# Battery Based Energy Storage System for the Fox Hills Sub Station Site

## Response to clarifying questions 16-Oct-2020

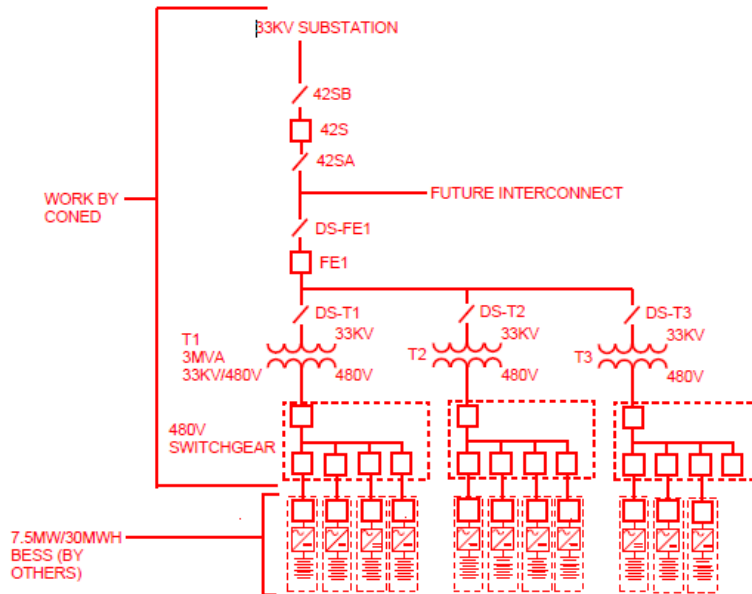
**A:** *Yes, the Point of Common Coupling is the same as the Point of Guarantee*
- Q:** Our understanding based on section 2.4.6 is that the project will be connected at 460V (480V Nominal). This means that all electrical apparatus needed to interconnect to the substation distribution feeder will be provided by Con Edison. Could Con Edison provide a conceptual single line for the project to confirm or correct this understanding?

**A:** *Below is a conceptual 1-line diagram. The secondary side will be finalized based on input from the chosen Vendor; The primary side is still in the design phase*
